CAMPAIGN 5700 - Recall Campaign
Fiat Ducato Model with 2.0 JTD Euro 5 engine
- POWER STEERING HYDRAULIC SYSTEM

RECALL CAMPAIGN 5700

**Fiat Ducato Model with 2.0 JTD Euro 5 engine
- POWER STEERING HYDRAULIC SYSTEM**

Fig. 1

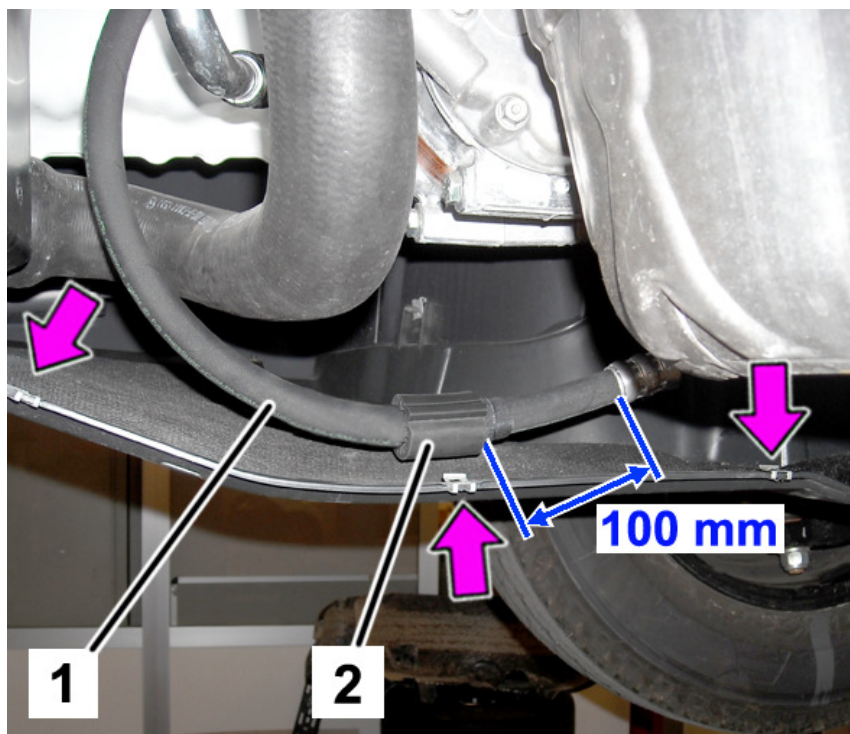
- Remove the centre under-engine guard and its clips.
- Apply a protection rubber pad (2) on the pipe (1 - Fig. 1) in the interference point, as shown.

- Fasten the centre under-engine guard using new screws, part no. 1372898080 and new clips, part no. 14369071, taken from the Spare Parts Dpt.

NOTE: only if the pipe is scratched or damaged replace it, with reference to Op. 4130B40 of the Service Manual and restore/bleed air from the power steering hydraulic circuit, with reference to Op. 0010T71 of the Service Manual.
